Title - Sujet Parking Lot Repair JAG Bldg PEI	
Solicitation No. - N° de l'invitation ED001-170593/A	Amendment No. - N° modif. 002
Client Reference No. - N° de référence du client R.074056.001	Date 2016-07-06
GETS Reference No. - N° de référence de SEAG PW-\$PWC-023-3902	
File No. - N° de dossier PEI-6-39030 (023)	CCC No./N° CCC - FMS No./N° VME
Solicitation Closes - L'invitation prend fin at - à 02:00 PM on - le 2016-07-12	
Time Zone Fuseau horaire Atlantic Daylight Saving Time ADT	
F.O.B. - F.A.B. Plant-Usine: <input type="checkbox"/> Destination: <input checked="" type="checkbox"/> Other-Autre: <input type="checkbox"/>	
Address Enquiries to: - Adresser toutes questions à: Ellis-Herring, Alison	Buyer Id - Id de l'acheteur pwc023
Telephone No. - N° de téléphone (506) 636-3908 ()	FAX No. - N° de FAX (506) 636-4376
Destination - of Goods, Services, and Construction: Destination - des biens, services et construction:

This Solicitation Amendment No. two (2) is raised to include the following addendum no. 2.

Addendum No. 2.

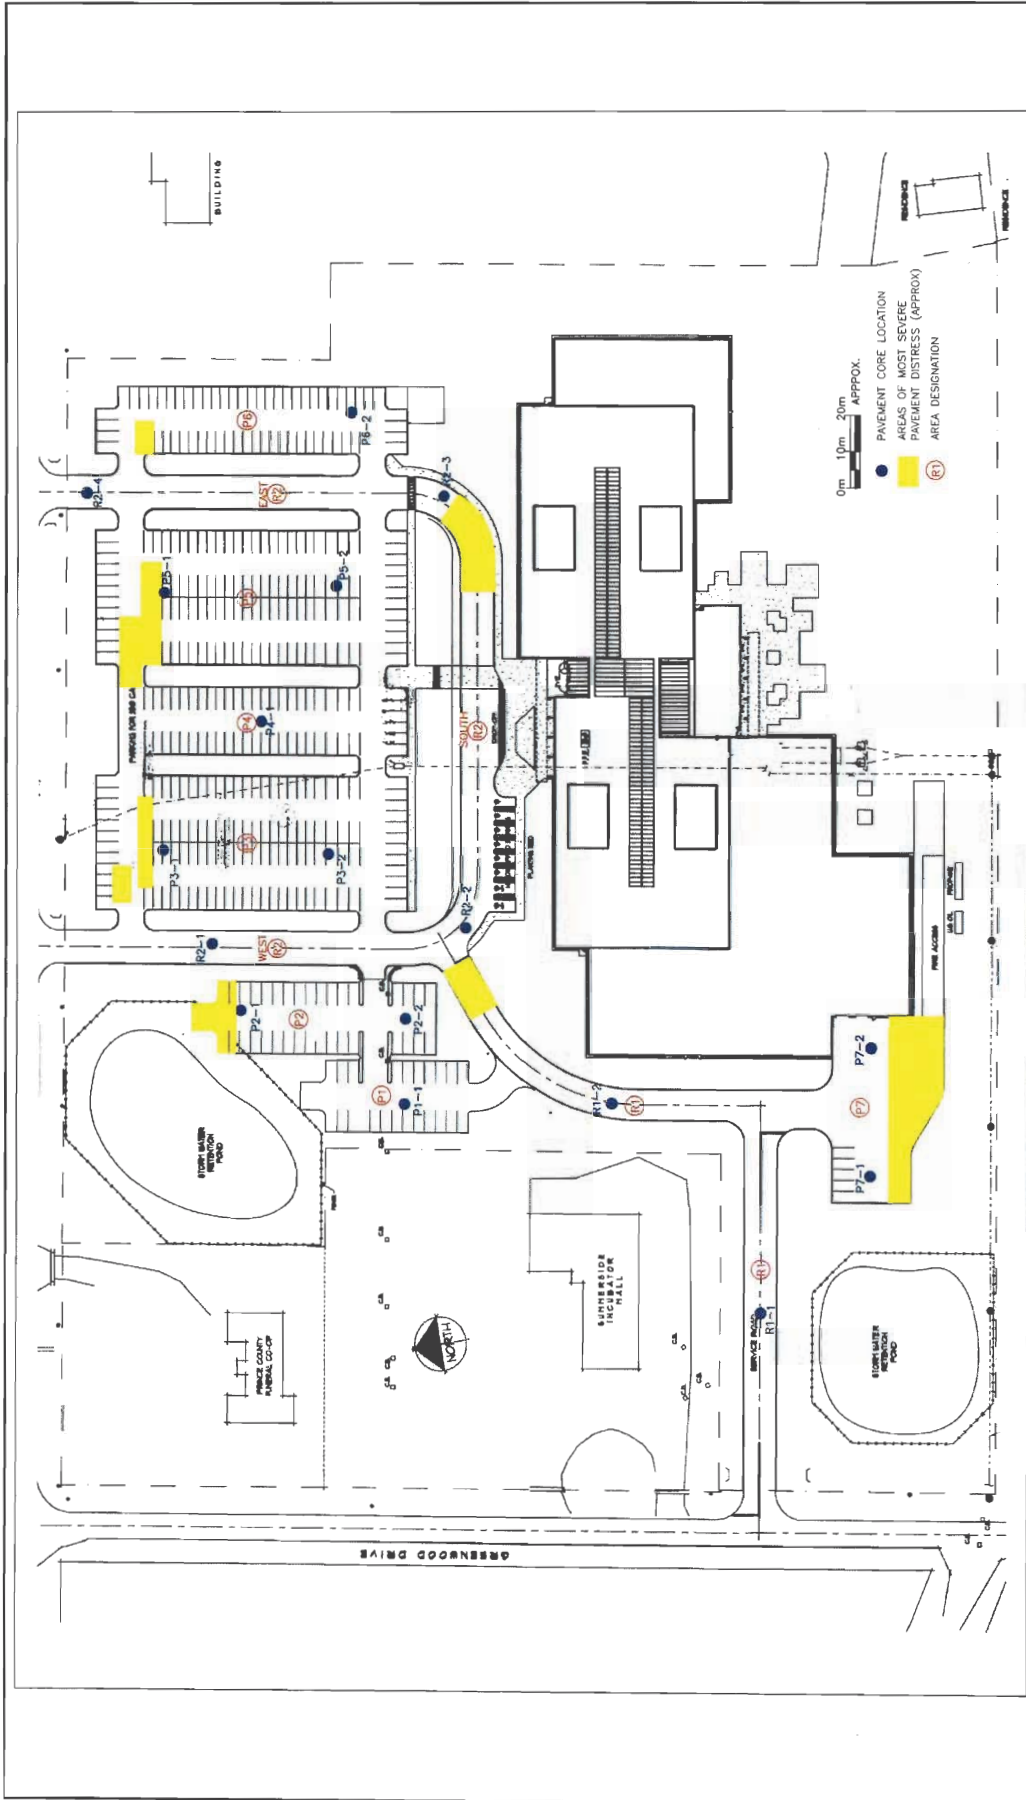
I do not see an appendix A in the documents and as it is vital to know the existing thickness, Can you please provide any information on this that you have. We will need to know the thickness to calculate the price per M2 for the removal of asphalt.

A2. See attached, "Table 1 – Pavement Coring Summary" and Dwg No. 1 titled "Pavement Condition Assessment".
